CONSTRUCTION DOCUMENTS - GRADING CBP, F2-LOT #21 - CRACKERJACK MUD JACKING, INC 7315 McCLAIN POINT, COLORADO SPRINGS, CO

GRADING COVER SHEET

Markup Summary

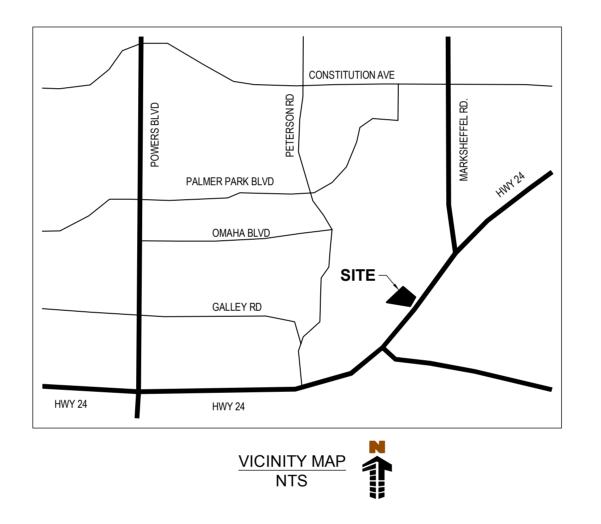
Add after the 2nd paragraph:

In accordance with ECM Section 1.12, these construction documents will be valid for construction for a period of 2 years from the date signed by the El Paso County Engineer. If construction has not started within those 2 years, the plans will need to be resubmitted for approval, including payment of review fees at the Planning and Community Development Directors discretion.

Replace with the following: [Name, Title] [Business Name]

Note: Provide the actual information

Replace with "Grading and Erosion Control Plan"

Include Contact Informations such as:

Owner, Design Engineer, El Paso County Planning and Community Development, Utility companies, Contractor

Add: PCD Project No. PPR-17-031

GRADING PLAN

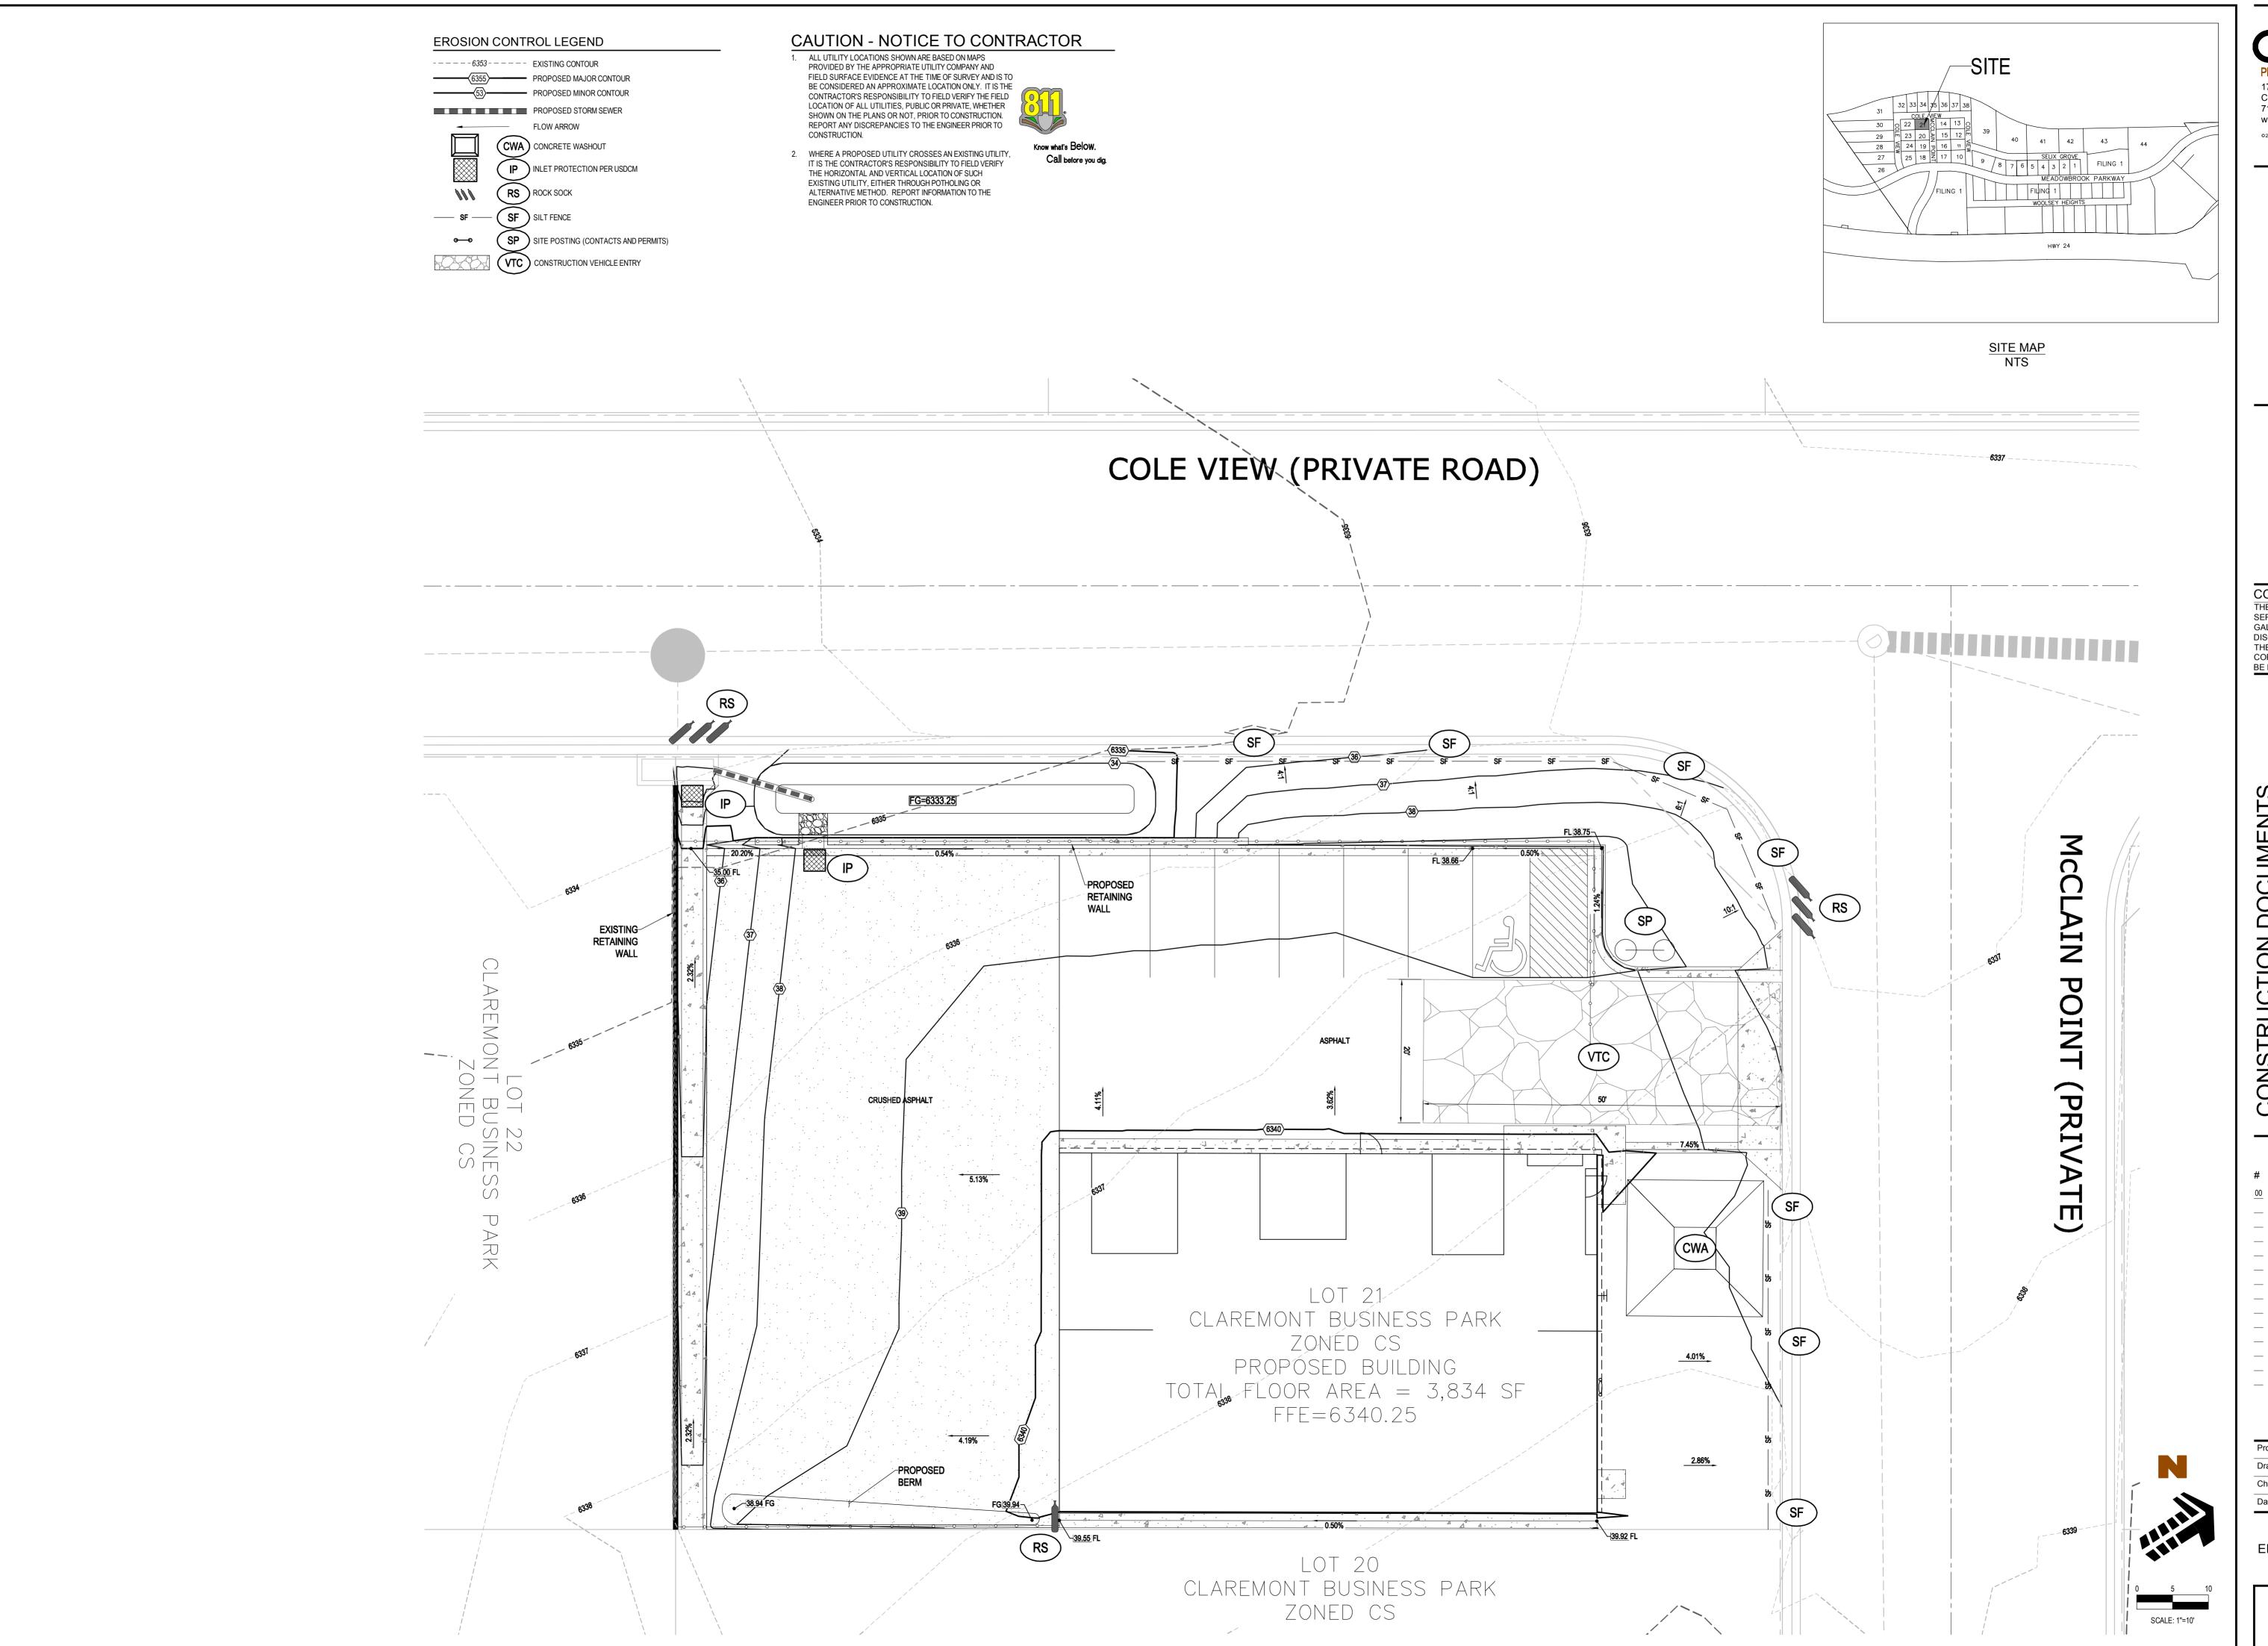
Show and label the drainage easement along the lot line.

Show the actual retaining wall cross section which includes the footers.

Since the retaining wall is greater than 4 feet in height building permit is required.

Therefore, add a callout stating a building permit is required for the retaining wall.

Revise linework so the ground slopes towards the pond.

Identify the riprap LxWxD and D50 Size.

Show and label both the WQCV and 100yr water

Callout the lowest top of curb elevation fronting the rain garden.

Per the CBP Fil 2 FDR, Q5 & Q100 will be directed to the private 10' Type R inlet which has the throat opening facing into the property.

Current design and the narrative of the drainage letter indicates runoff over-tops onto Cole View instead of being directed into the inlet. Runoff from a 100yr storm must drain into the inlet, not the street.

Label to lot lines and easements.

Include the bearing/distance for the lot lines.

Identify the side slopes for the berm.

Based on the grading, this area is not routed into the rain garden. Update the design so this area is

treated by a WQ BMP.

RAIN GARDEN DETAIL

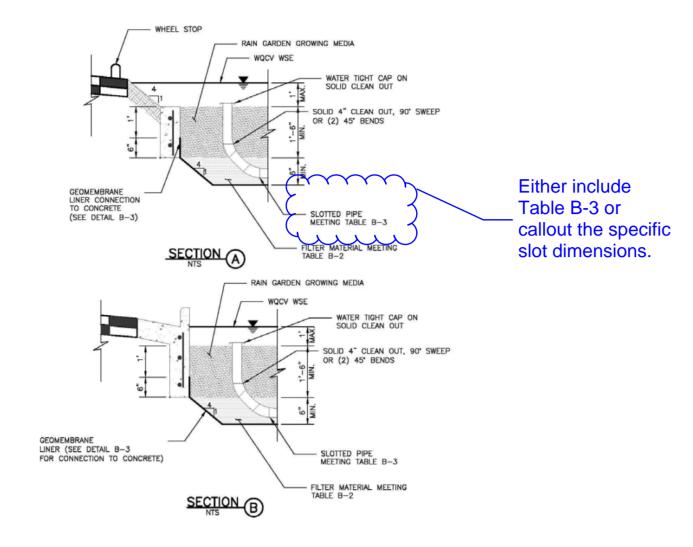
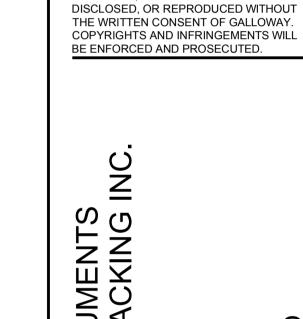
Include a cross section detail for the slotted pipe connection to the riser pipe and orifice plate per the drainage report.

Either include Table B-3 or callout the specific slot dimensions.

Include a cross section detail for the slotted pipe connection to the riser pipe and orifice plate per

Show the Slotted Pipe and label the length and
